## ADDENDUM

NO. 01

**PROJECT NAME:** 2025 Multi-Campus Chiller Replacement

**CLIENT NAME:** Cypress-Fairbanks ISD

## 2 PARTIAL CHILLED WATER PIPING DIAGRAM

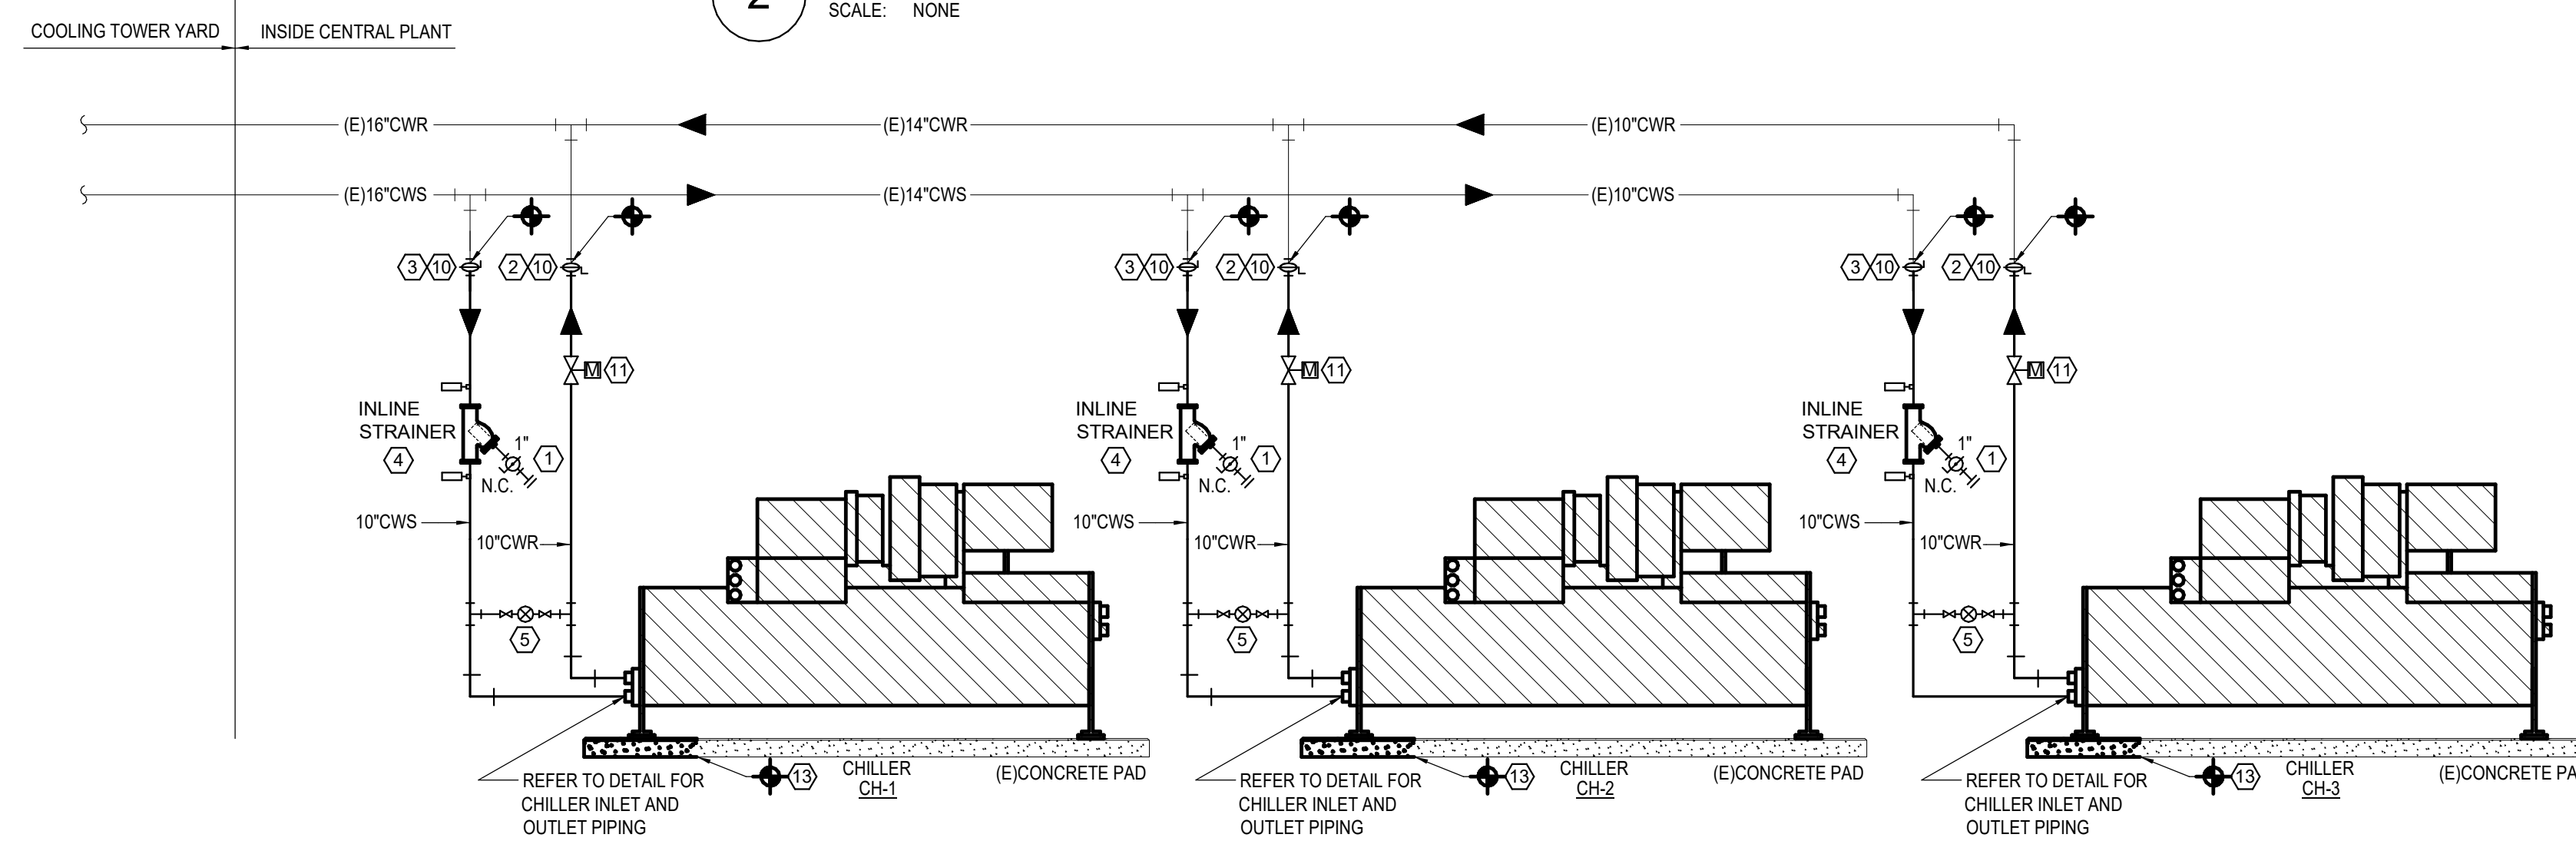
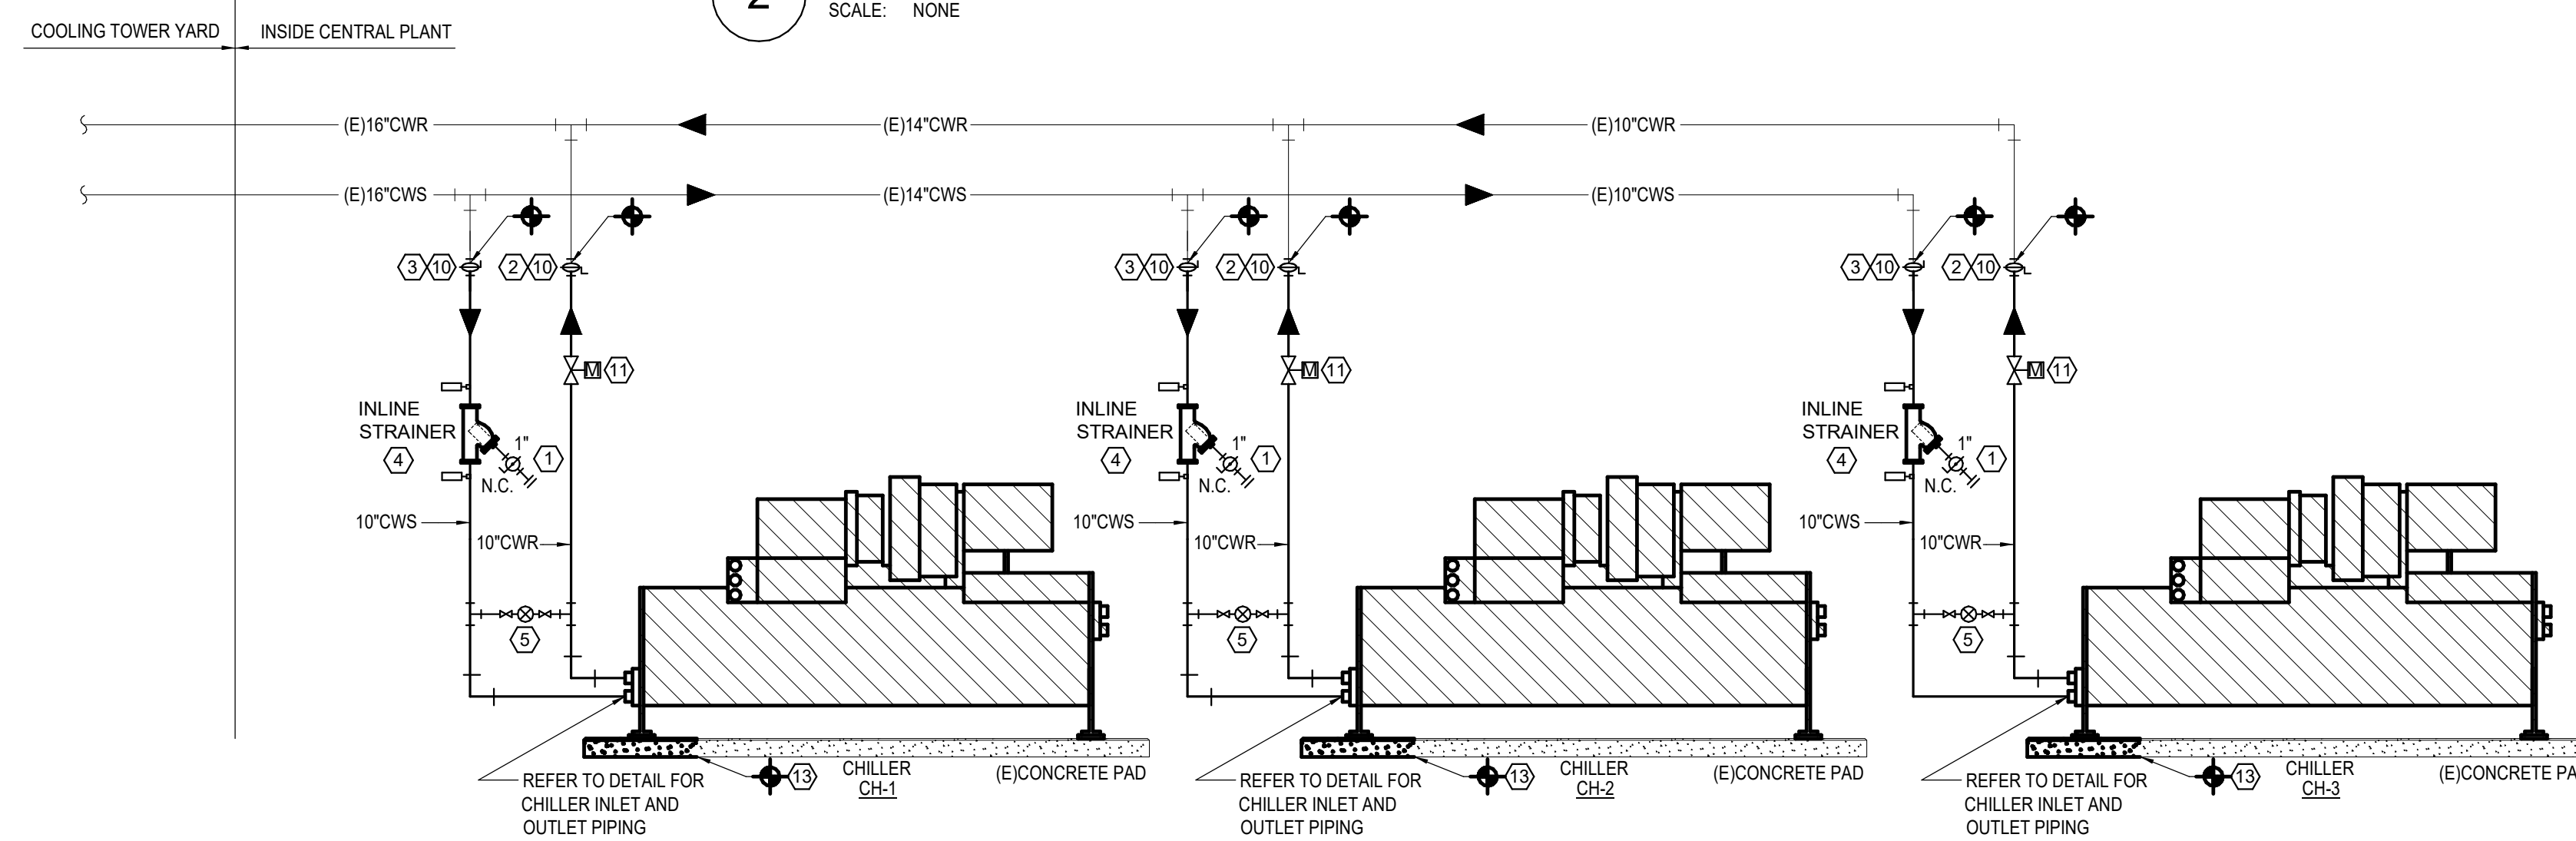
AD No 2, Mech. Item 4: **To the Drawings, Sheet M3.01-BC, "MECHANICAL PIPING DIAGRAM"**

- a. Refer to attached drawing for revised decoupler.

MECHANICAL SCHEDULES, LEGENDS, AND DETAILS

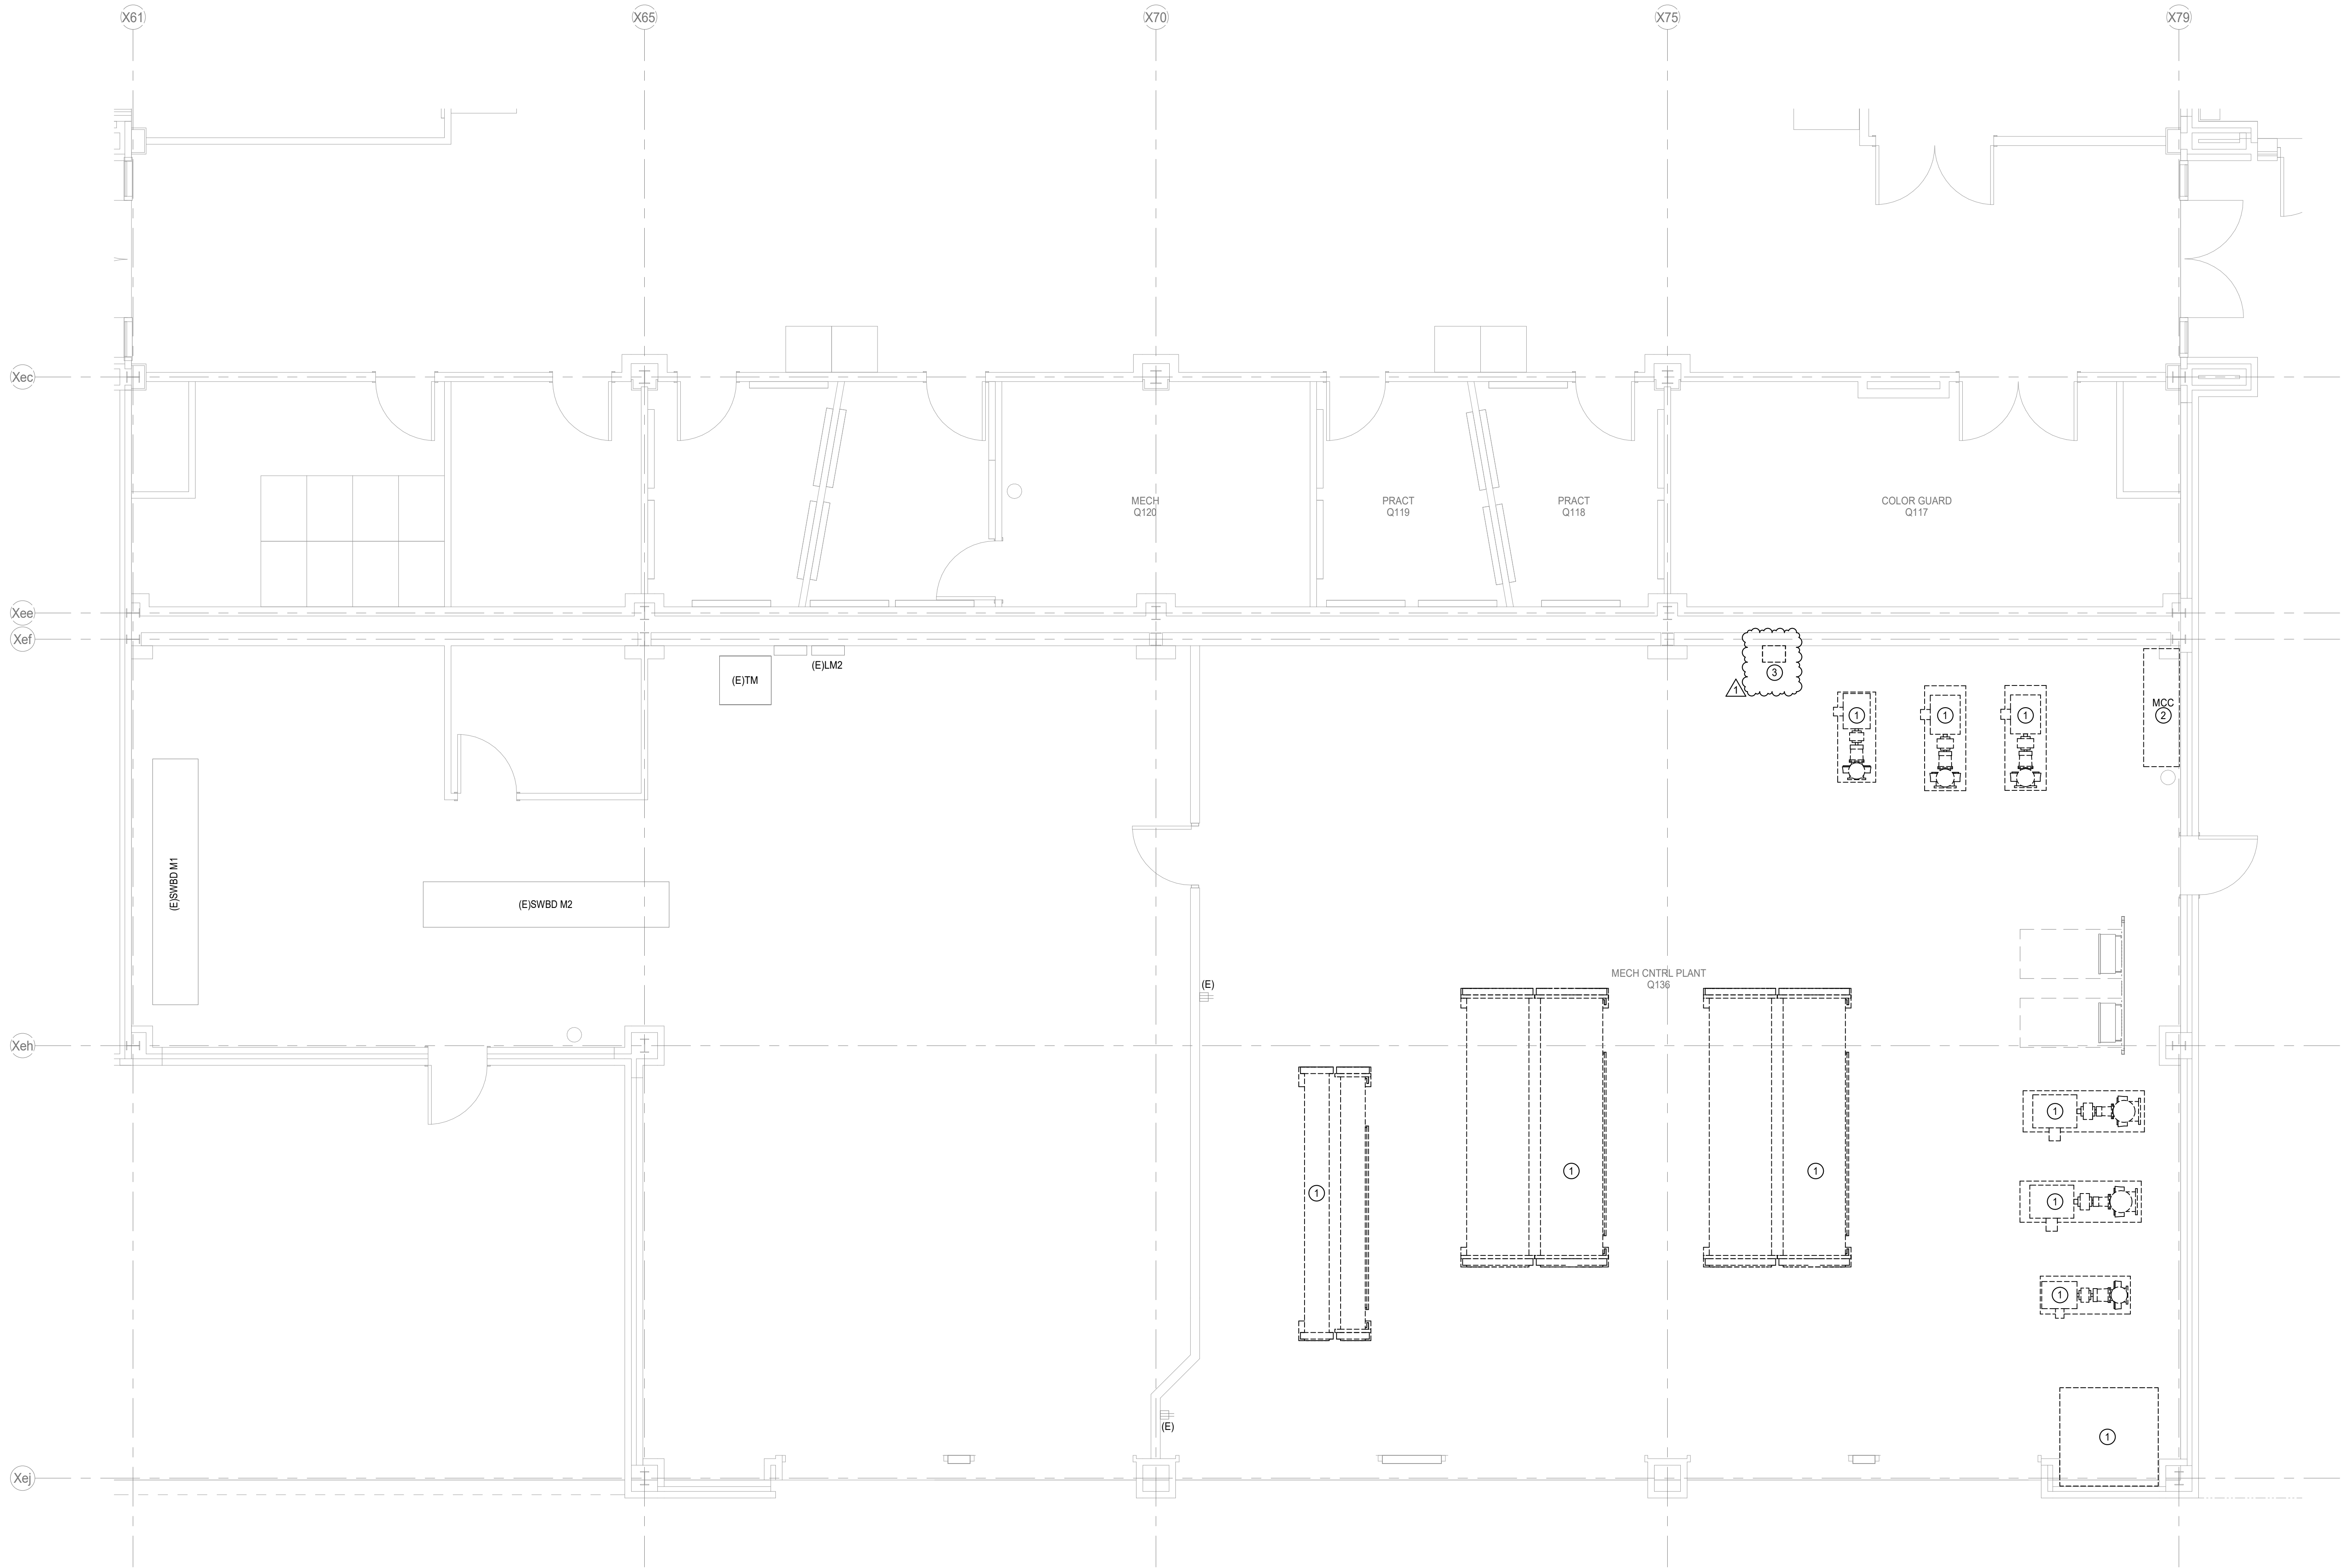
AD No 2, Mech. Item 5: **To the Drawings, Sheet M4.01-BC, "MECHANICAL SCHEDULES, LEGENDS, AND DETAILS"**

- a. Refer to attached drawing for revised WATER COOLED CHILLER – MAGNETIC CENTRIFUGAL WITH VFD SCHEDULE.
